AGENDA MEMORANDUM

Planning Commission Meeting of August 18, 2021

Highland Oaks Unit 6 (Final)

Request for a Waiver for Modification to the Street Right-of-Way Dimensional Standards

TYPICAL 1/2 STREET CROSS SECTION CARIBBEAN DRIVE

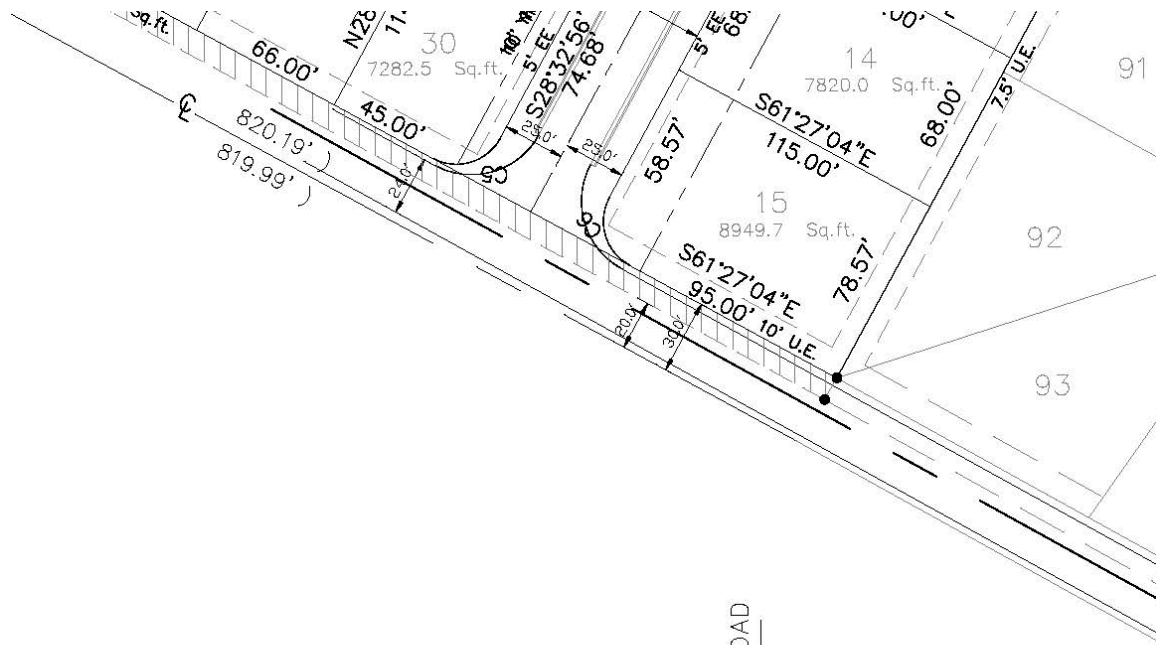
The applicant originally requested a half street construction of the C1 minor collector along the south boundary of the plat extended to St. Frances Street (Exhibit B). The property to the south is a military base, and it is unlikely that it will be platted in the foreseeable future. Thus, instead of the half street, the City recommends the construction of a modified 50-foot street section for Caribbean Drive with a 28 ft. pavement section (BB) and one sidewalk on the north. The street requirement layout can be seen on Exhibit A below. The extension requirement is necessary to meet UDC Section 8.2.1.E for the minimum external access points for a subdivision. The plat, Highland Oaks Unit 6, has 88-units requiring 2 access points with the second access point being St. Frances Street. The applicant has agreed to the City's recommendation.

Staff recommends approval of the waiver for a modified street section of the Non-Local Street Standards in Unified Development Code (UDC) Section 8.2.1.B. Street Right-of-Way Dimensional Standards, Table 8.2.1.C .providing for a 50 ft. right-of-way, 28 ft. pavement section (BB) and one sidewalk on the north for Caribbean Drive. The Planning Commission may choose to follow or decline Staff's recommendation, and Planning Commission may approve, approve with conditions, or deny the waiver request.
